**MEMPHIS AND SHELBY COUNTY OFFICE OF PLANNING AND DEVELOPMENT**  
**STAFF REPORT**

**CASE NUMBER:** PD 08-304 **L.U.C.B. MEETING:** February 14, 2008

**DEVELOPMENT NAME:** RBM Cherry Road Partners Planned Development

**REQUEST:** Amend the P.D. to Transfer 1.3 acres from Lot 2 to Lot 1 and add parking between the existing building and Cherry Road in Lot 1.

### Proposed Landscape Plan

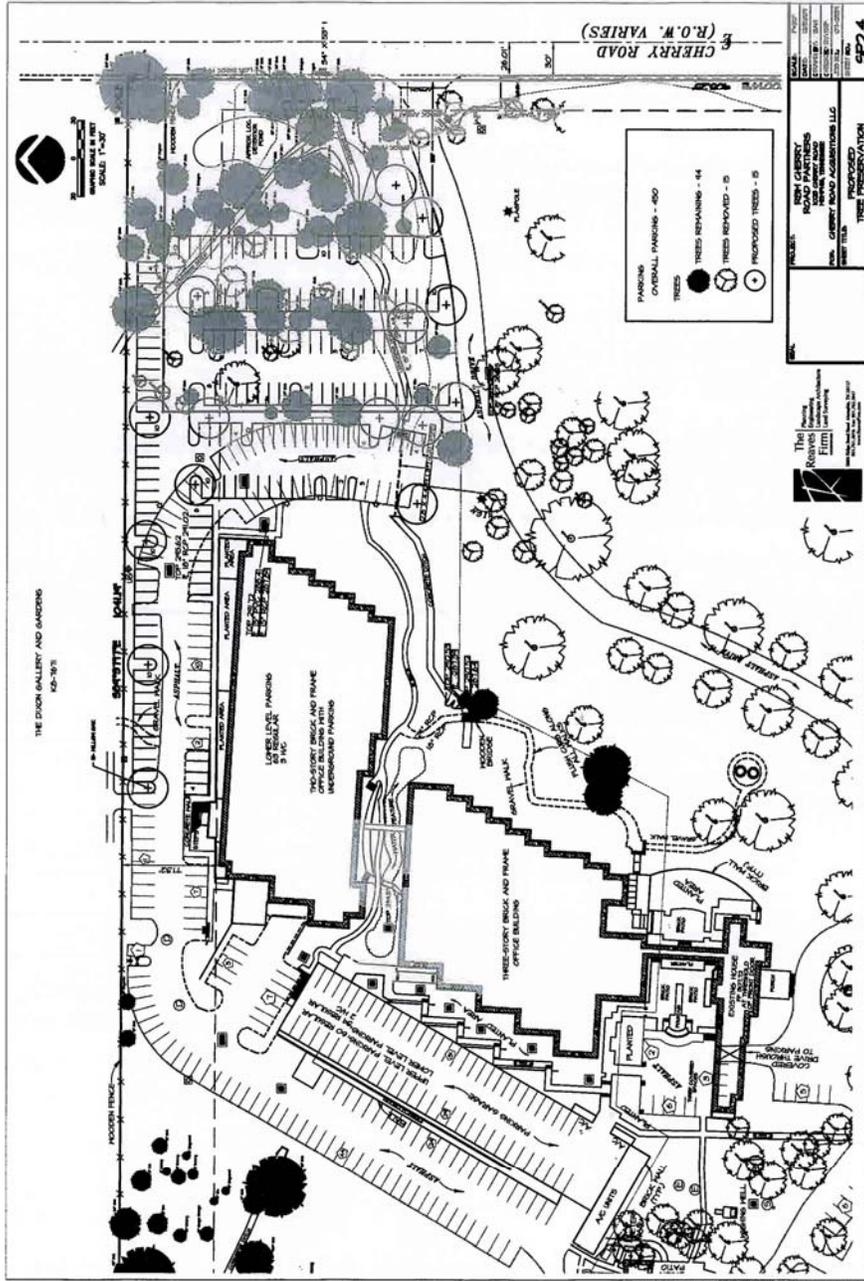
The proposed landscaping plan shows two landscaped islands of approximately 15 feet in width which will increase the likelihood that many of the existing trees that are currently located within the proposed parking area may survive. The plan also shows a desire to replace trees that are lost on a one for one basis.

TIC Properties has adequately addressed our concerns regarding visual intrusion into the neighborhood by placing their expanded parking area on the East side of the buildings away from the neighbors, saving existing trees as noted on their plan, providing for undisturbed natural area along Cherry Road and adding evergreen screening around the new parking area.

1. ***A landscaping plan for the proposed additional parking in Lot 1 shall be submitted to the Office of Planning and Development for approval. The landscape plan shall be designed to screen the parking area from Cherry Road. Development of the parking area including specific measures for preserving existing trees shall be incorporated into the overall landscape plan. No final plan shall be approved until a landscape plan including the specific parking development plan is approved.***

3. ***The area between Cherry Road and the expanded parking lot and north of the access easement shall be identified as open space-unbuildable.***
